April 11, 2019

To: Ridgeland WRF Expansion Plan Holders

Re: Addendum #1
Ridgeland WRF Expansion

SHEET NO.
G021
OF
FILE NO.
1636.6

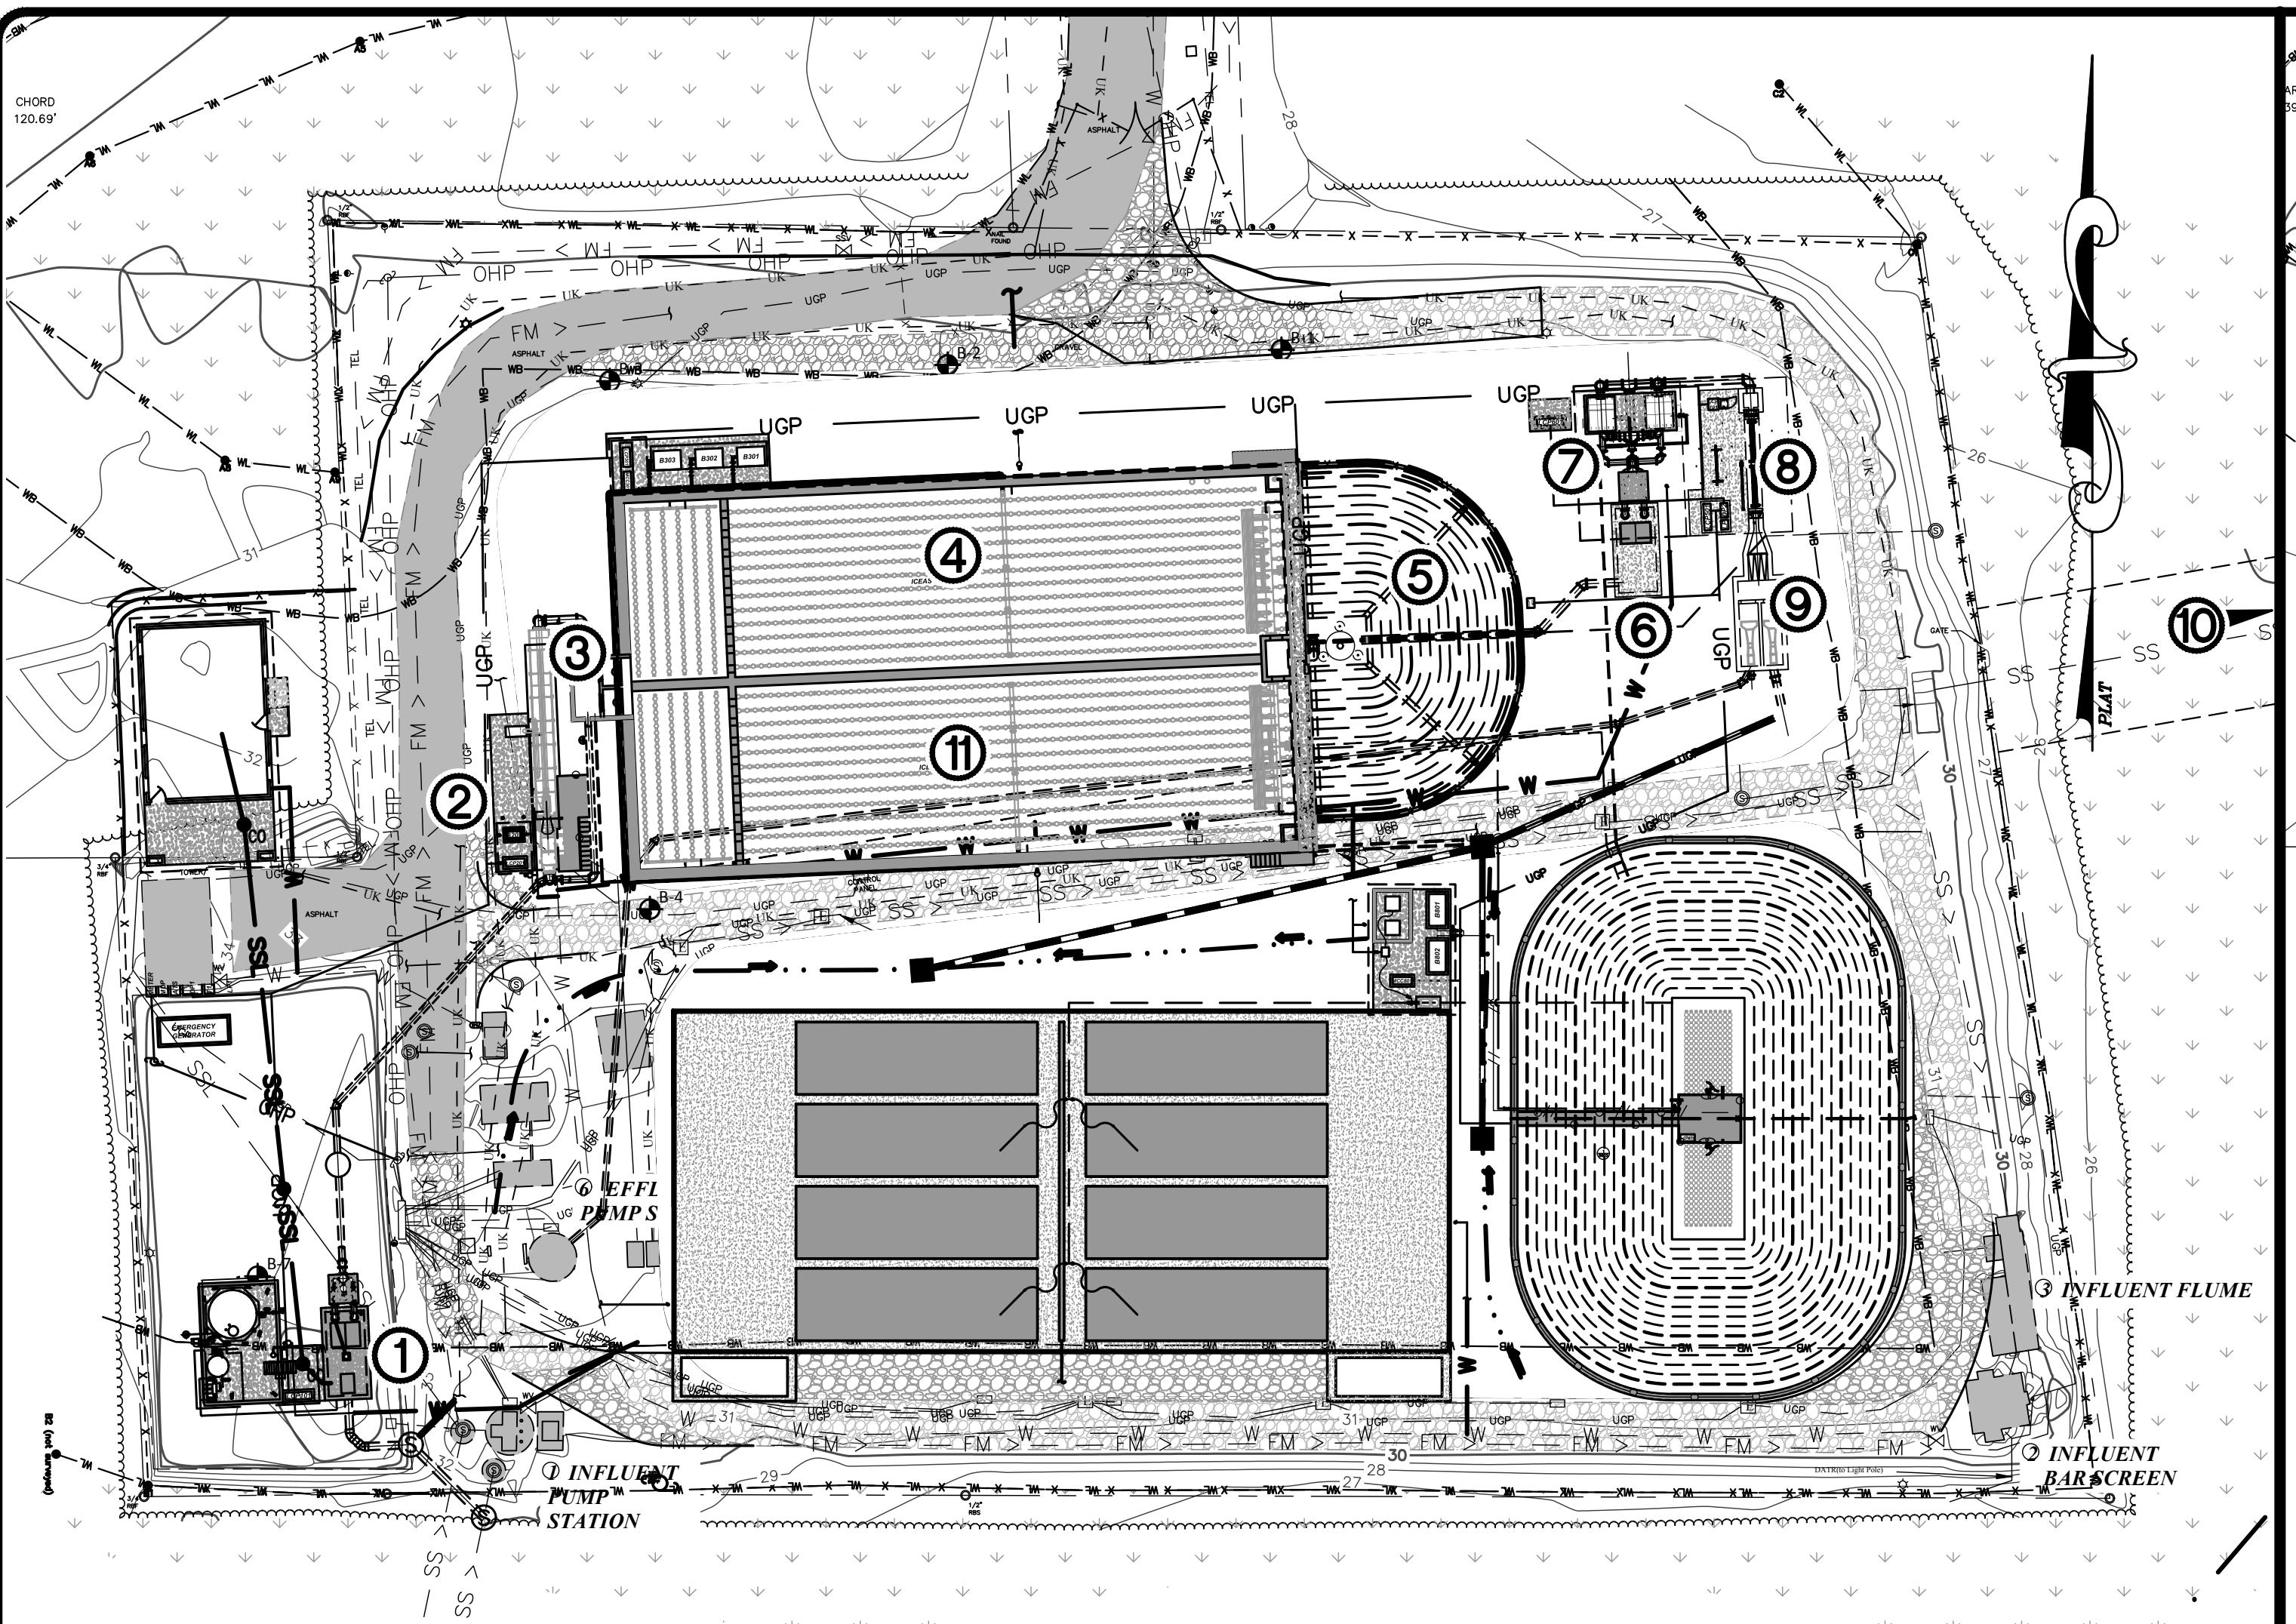
3. The ICEAS tank has been shifted south 21 ft in order to reduce excavation costs. It will remain at its original elevation. The construction sequence is being revised to show the ICEAS Train #1 being constructed and brought on line, then ICEAS #2 being constructed. We are working on the other drawings that show the details of this change, and will get them to you as soon as possible.

- A DIVERT FLOW FROM SOUTH LAGOON TO EFFLUENT PUMP STATION. STARTUP DAF / PUMP SYSTEM (IF REQUIRED)
- B REMOVE NORTH LAGOON LINER. REMOVE OUTFALL STRUCTURE. ICEAS #1 CONSTRUCTION. DRS BUILDING. GRADE DOWN PROPOSED INFLUENT AREA. 1.2
- C EQ POND. FILL AND GRADE AROUND ICEAS #1. INFLUENT PUMP STATION. ALKALINITY ADDITION FACILITY. OPS BUILDING. HEADWORKS. UNIT SLAB. COMBO UNIT INSTALL. SCREEN BYPASS. SPLITTER BOX. ICEAS BLOWERS. PUMP STATION. FILTERS (IF APPLICABLE). JV. POST EQ AERATORS. 1.4. SPLITTER BOX. PARSHALL FLUMES. LAS PUMP STATION PIPING. CREEK OUTFALL PIPING. INSTALL NEW GENERATOR. E PIPING FROM INFLUENT PS TO ICEAS TO JV'S TO CREEK. TEMPORARY SLUDGE HANDLING FOR ICEAS #1. 1.2

CLIENT	TOWN OF RIDGELAND
PROJECT	JIMMY MIXSON WRF EXPANSION
SHEET TITLE	INFLUENT PUMP STATION
FILE NO.	M101
OF	--

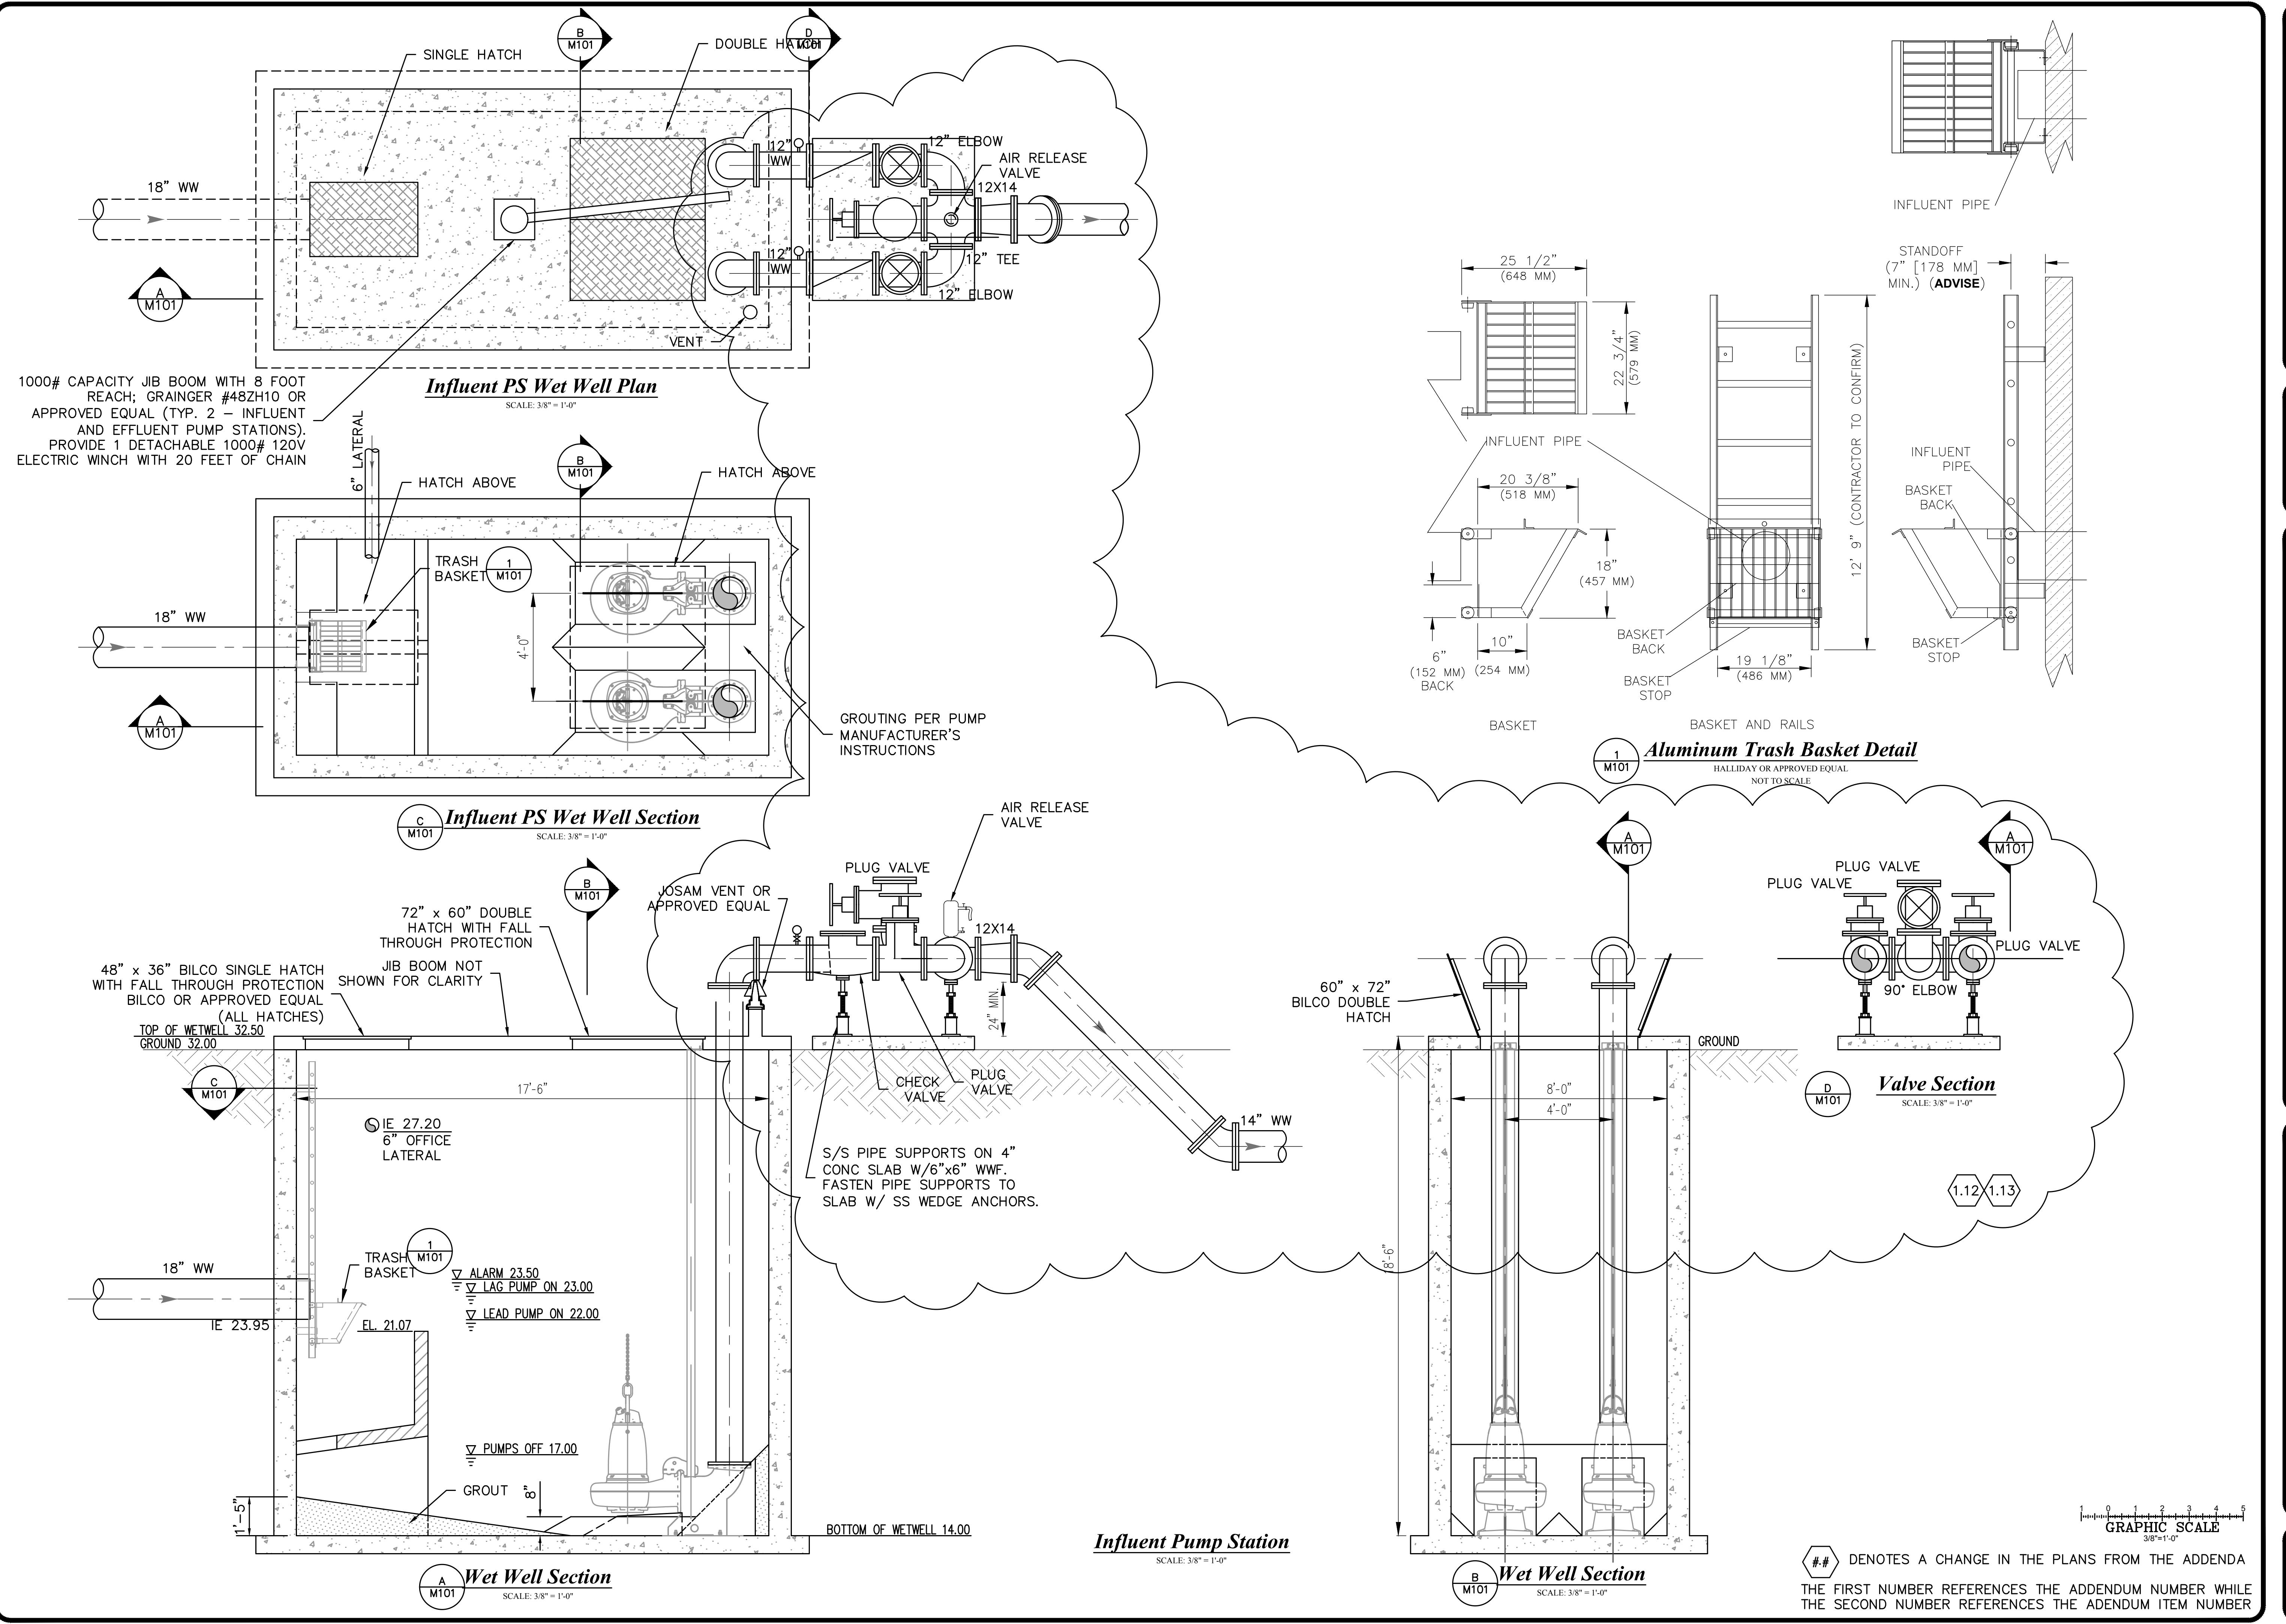
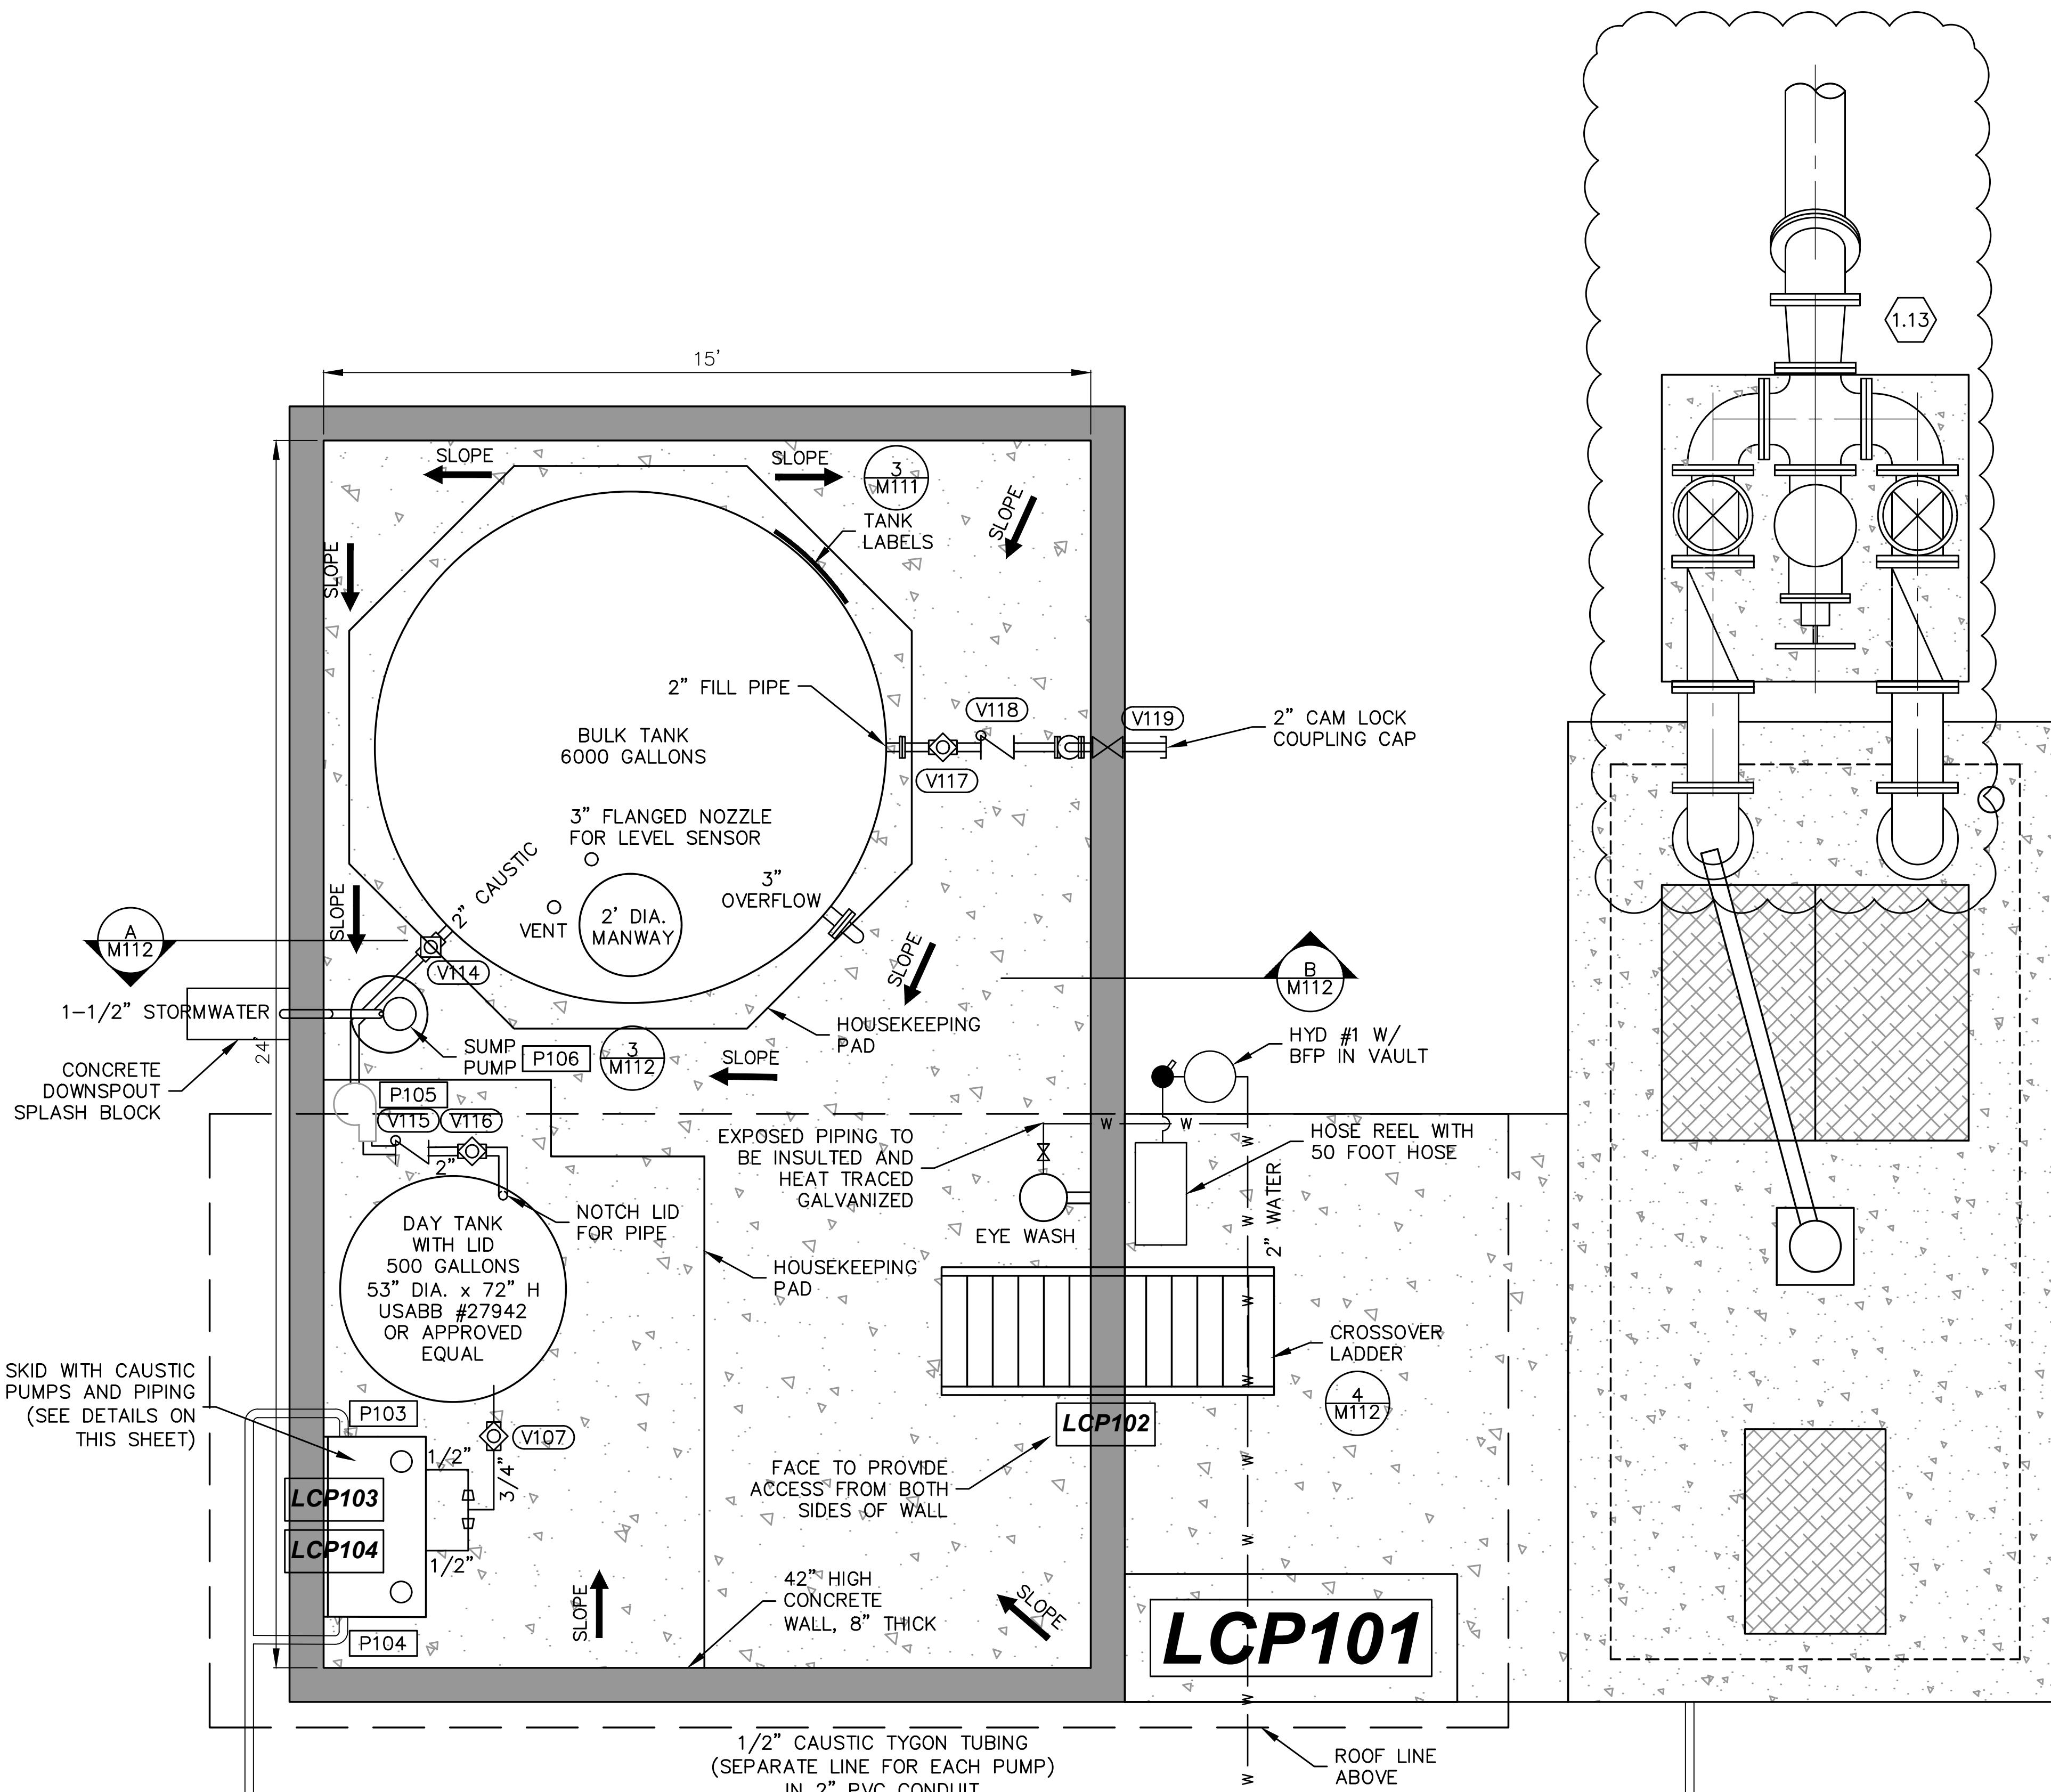
1.12	Influent pump station - M101	<ol style="list-style-type: none"> The existing pump station is 17.5' x 8' x 18.5' (Top of wetwell to bottom of wetwell). You may use a 20' x 10' x 17' box if that helps you with excavation costs.
